**Amendments to the Figures:**

## **REMARKS/ARGUMENTS**

Int. Appl. No.: PCT/US02/15387  
U.S. Appl. No.: 10/706,925  
Amdt. dated: July 19, 2005

**FIG. 1a**

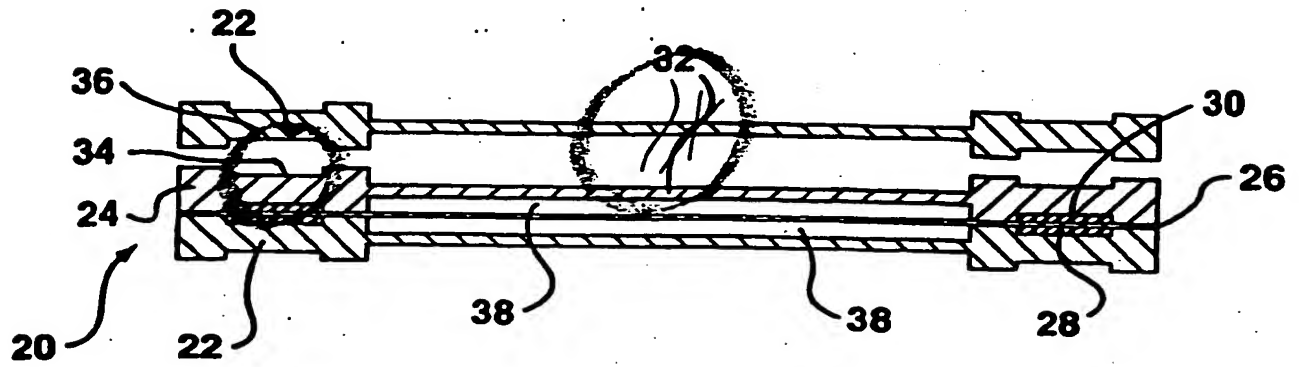
With respect to the drawings, amendments are being made to Figures 1a-e, 2, 7-12, and 17. In Figures 1 and 2, the amendments to the lead lines are intended merely to ensure that these drawings are wholly consistent with the specification and to aid in understanding the drawings. In Figure 7, the connection apertures have been labeled with reference numeral 160. In Figure 8, for consistency with Figure 7, the references 137, 139 and 141 now denote ports on the left hand side, while references 136, 138 and 140 denote ports on the right hand side. In Figure 9, the connection apertures have been labeled with reference numeral 160. In Figure 10, the reference numerals 182', 184' and 186' are, in effect, being switched with the reference numerals 182a', 184a' and 186a'. In Figure 11, at the right hand side reference numeral 160e has been

**FIG. 11**

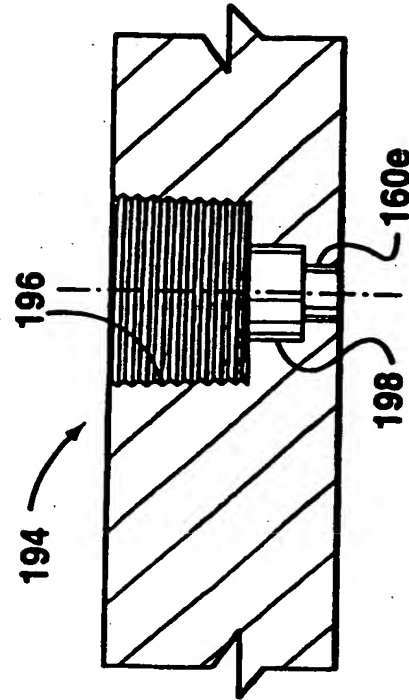
amended to read 160ae and the reference 160e added on the left hand side; at the top 132 has been corrected to 192. In Figure 12, the sealing aperture has been labeled with reference numeral 160e. In Figure 17, the lead line for reference numeral 146 has been extended to point to the sealing groove to ensure that the drawing is wholly consistent with the specification. These amendments are simply intended to ensure consistent use with the reference numerals used in the Figures and the description and for clarity in the drawings.
